Aurora Water (drainage)
comments in magenta red are
provided by Jared Coleman
(jcoleman@auroragov.org)

PRELIMINARY DRAINAGE REPORT

CORE Response

Murphy Creek – Zante Street
AURORA, COLORADO
CASE NO. XXXX

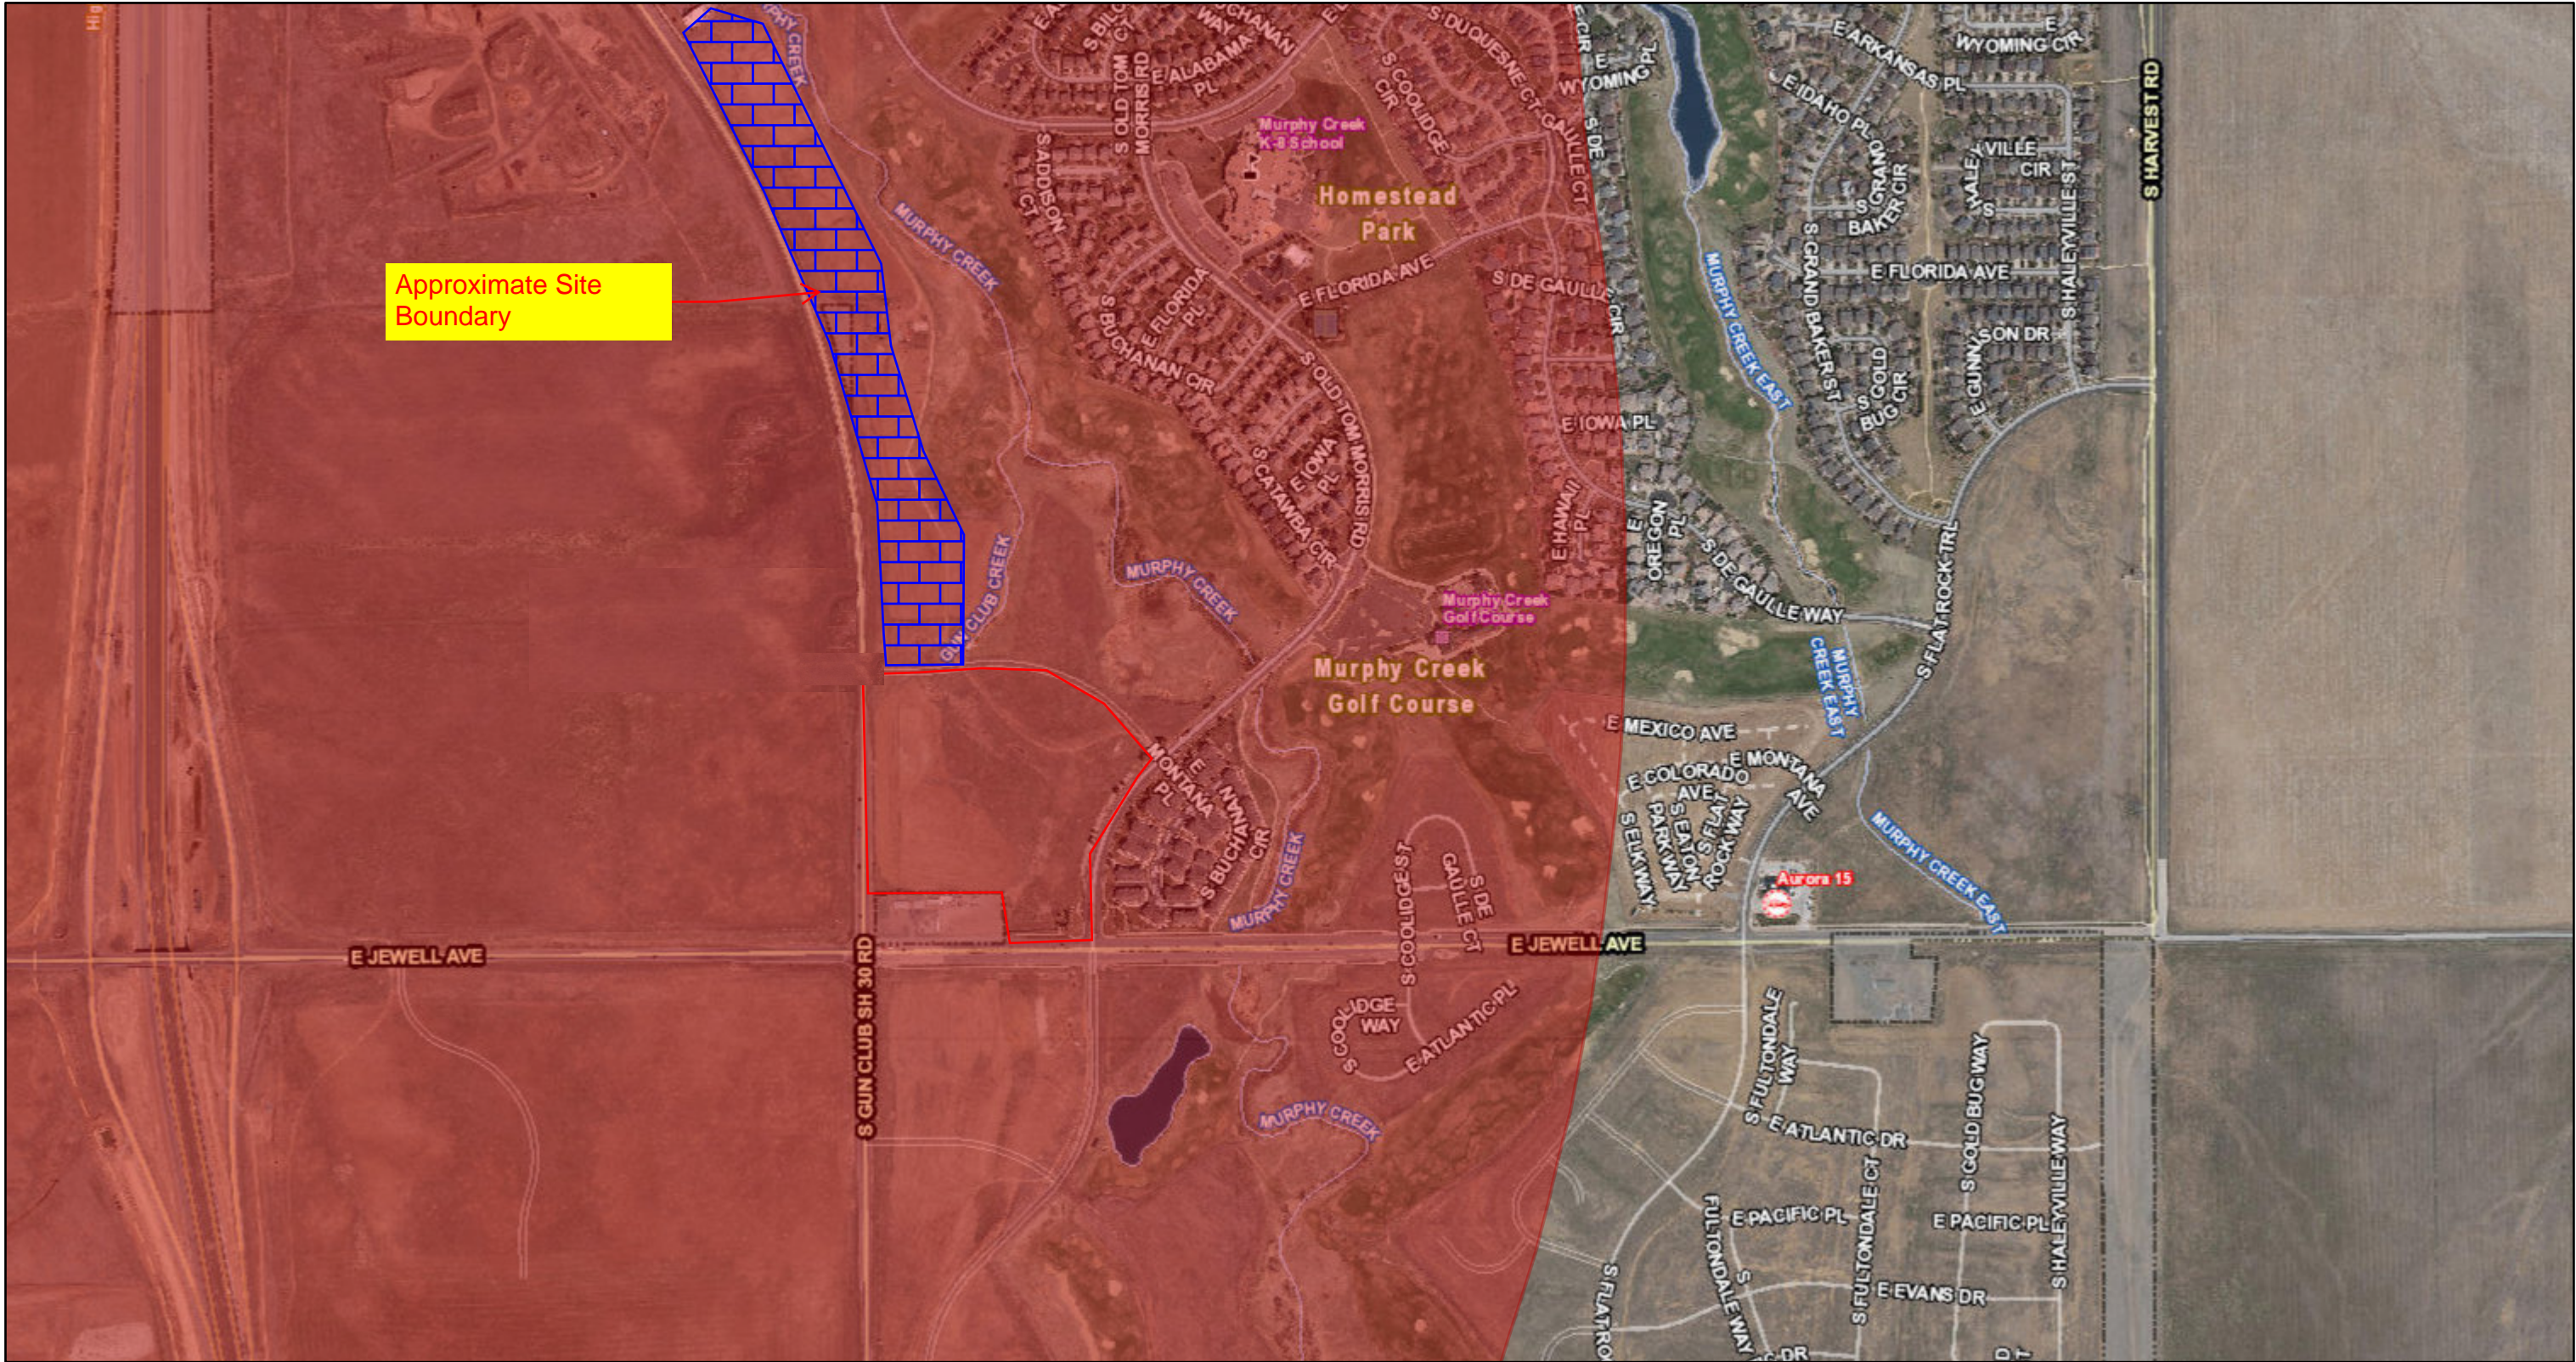
Also provide printout showing the soil type results (i.e. what soil type each MUS is)

Soil Maps updated to show hydrologic soil group on map with soil ratings included in the legend.

SUMP EMERGENCY OVERFLOW I

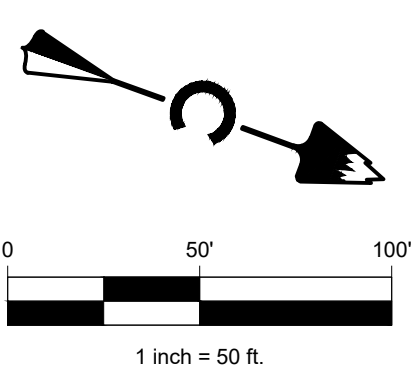
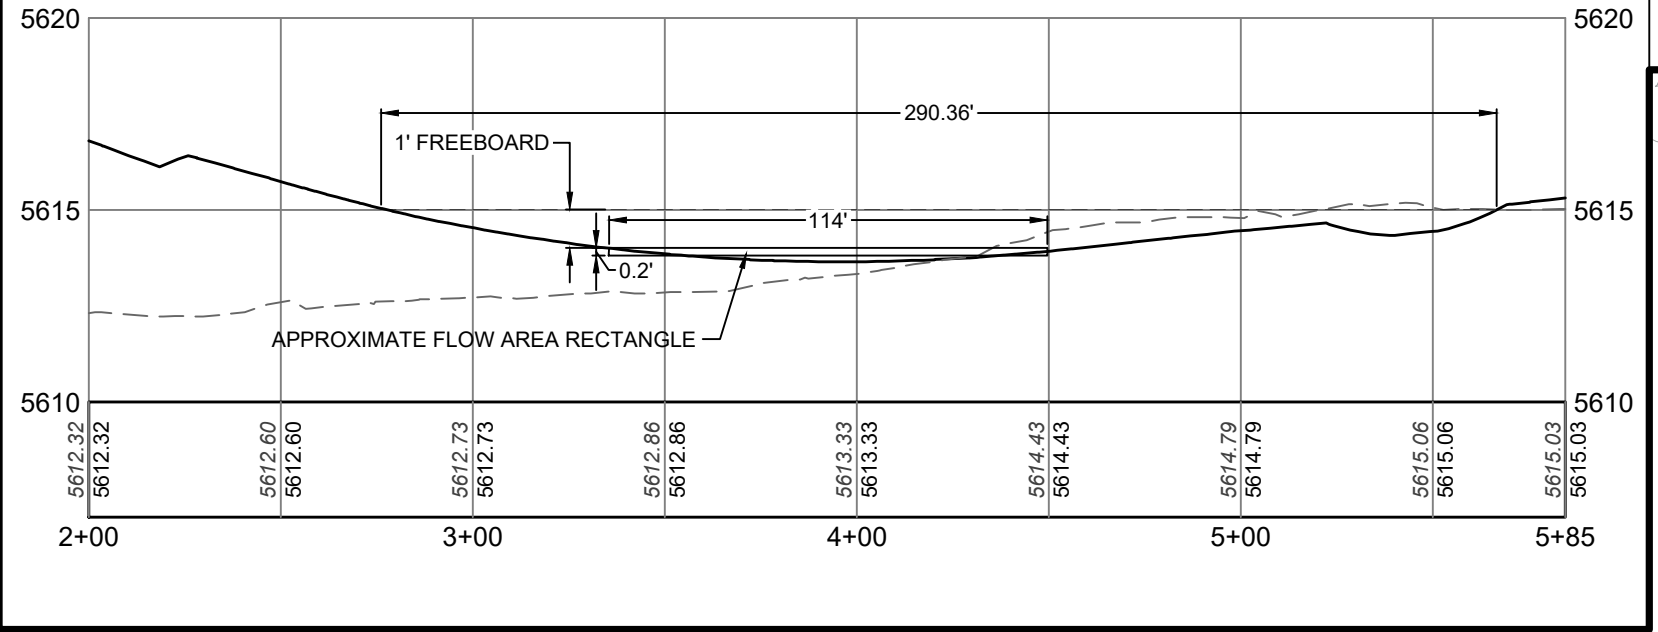
Ok. However, please note that both inlets don't need to be considered clogged, just the one that produces the most-conservative overflow scenario.

Noted. This approach has been maintained for a conservative approach and text has been added to the report for clarity.

JEWELL COMMONS PARCEL MASTER DRAINAGE MAP

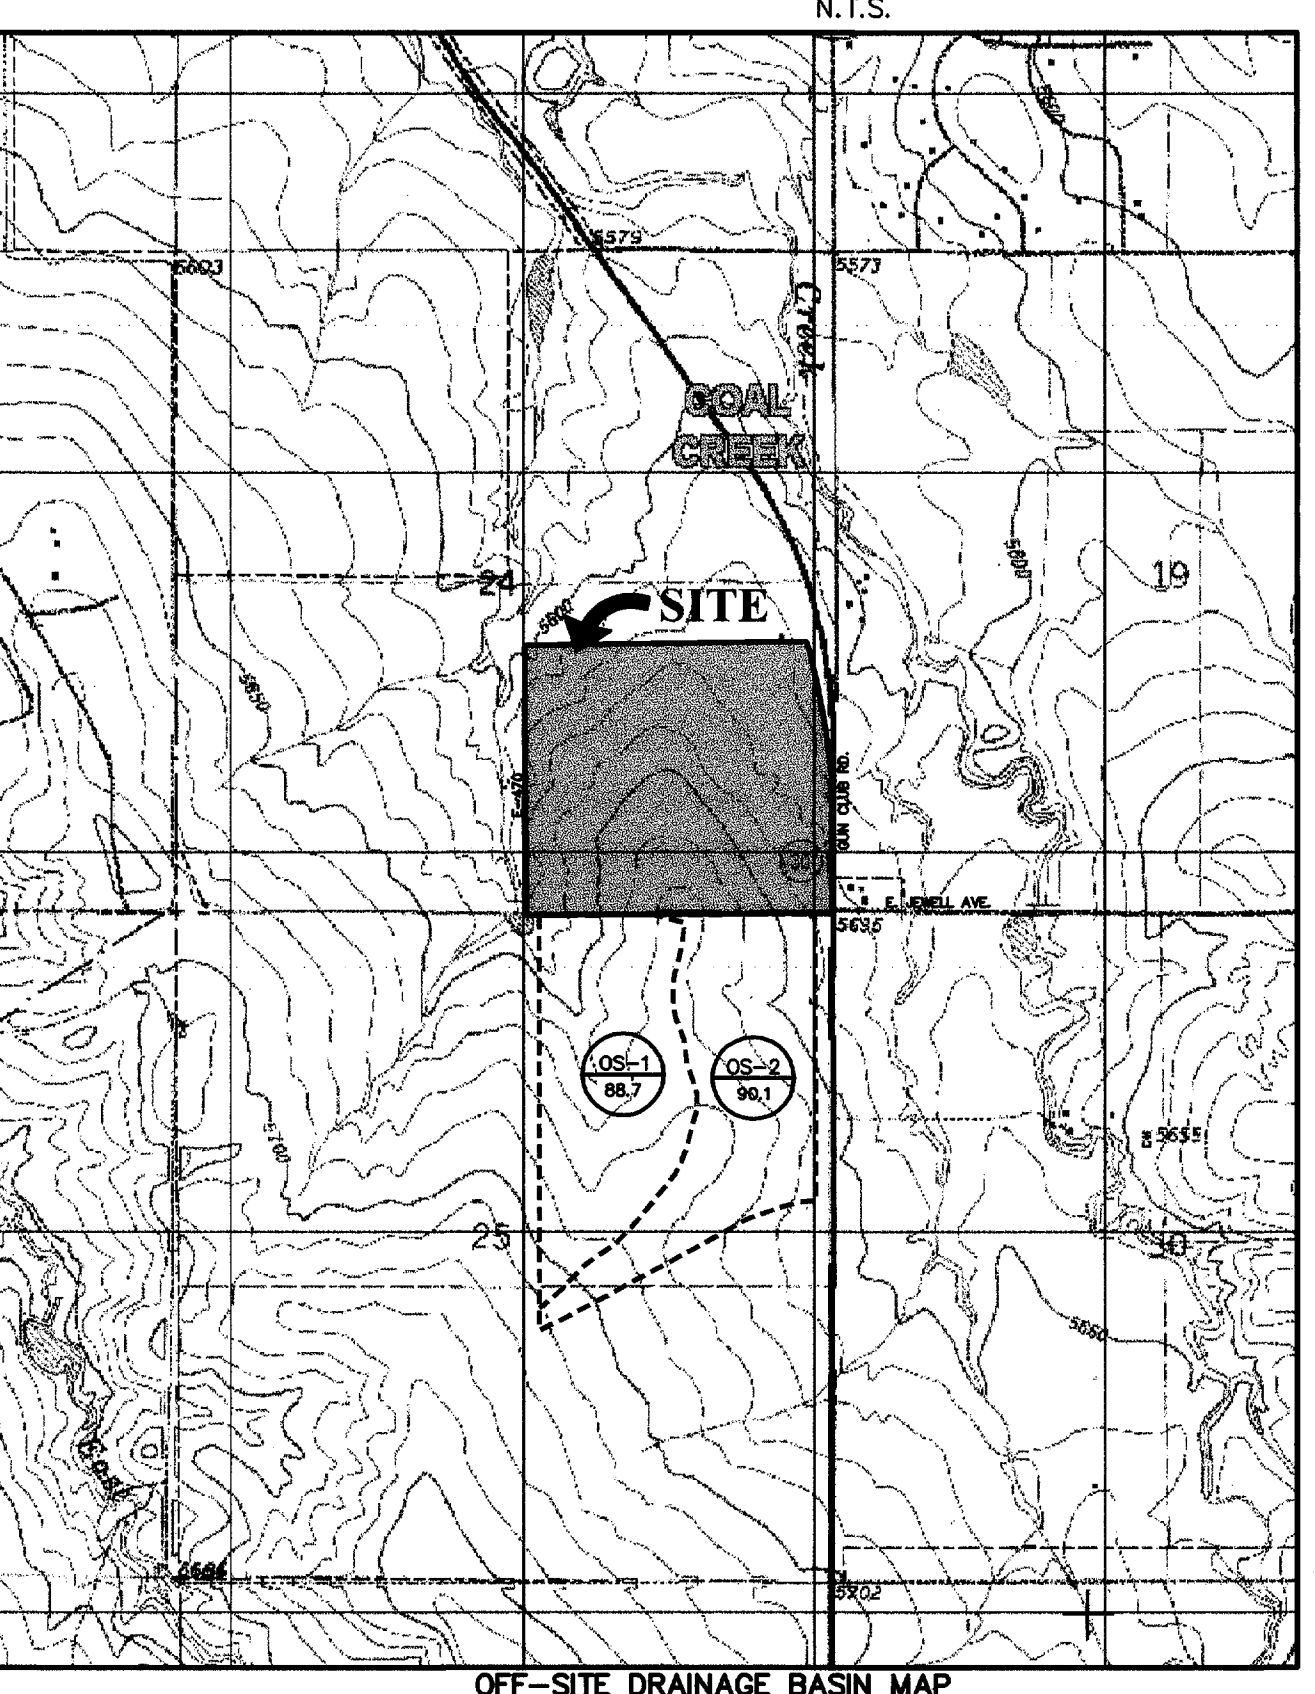
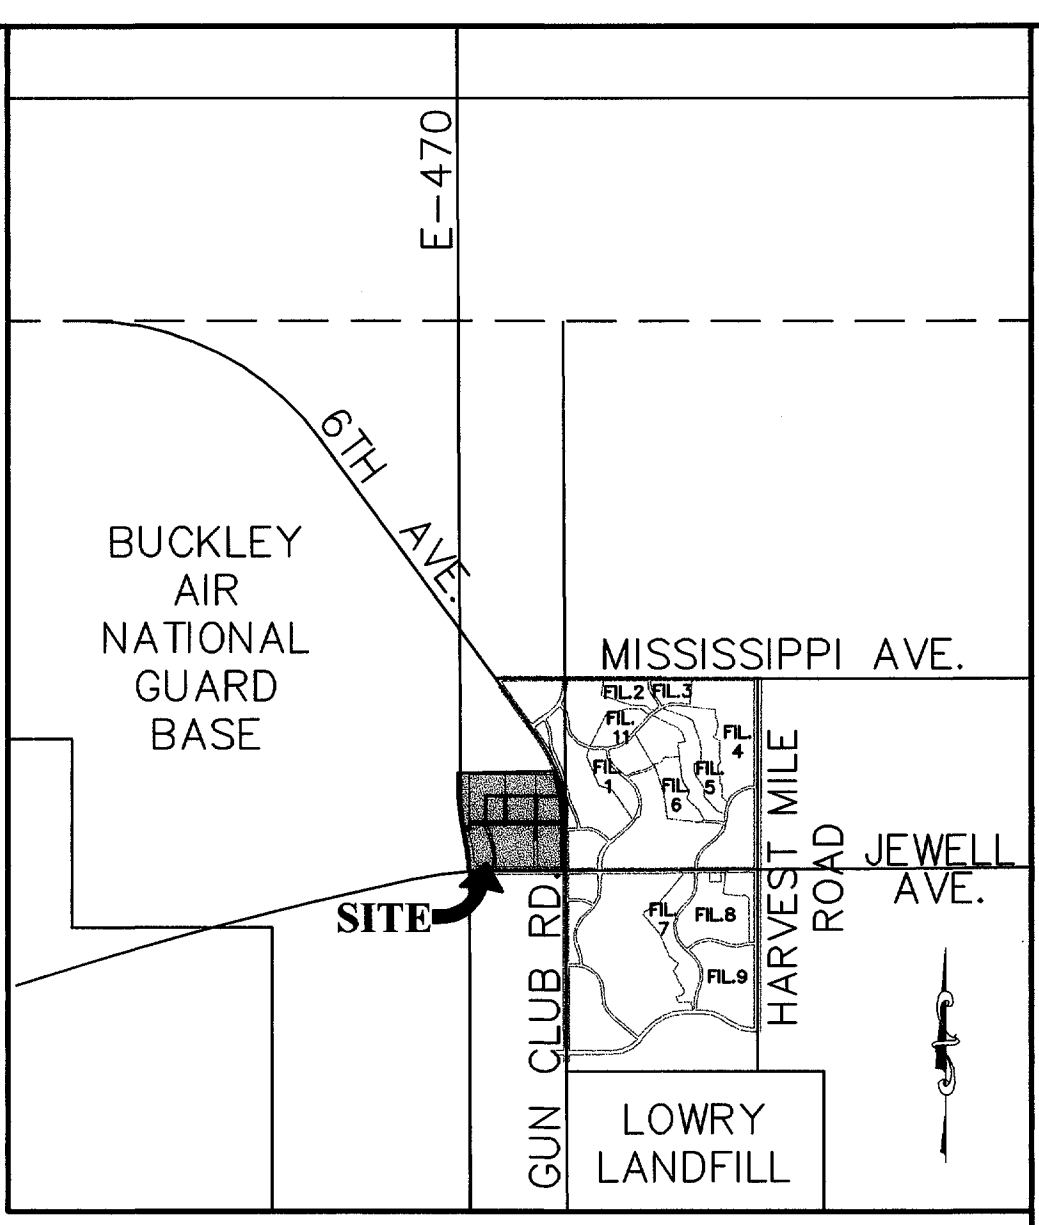
Pond 3 releases 19.3 cfs. For the Murphy Creek OSP, the entire offsite basin 380 including this pond will release 91 cfs into this 48" culvert.

this 24" culvert was removed and replaced with 5 Type D inlets per Prose at Murphy Creek Fig 01.
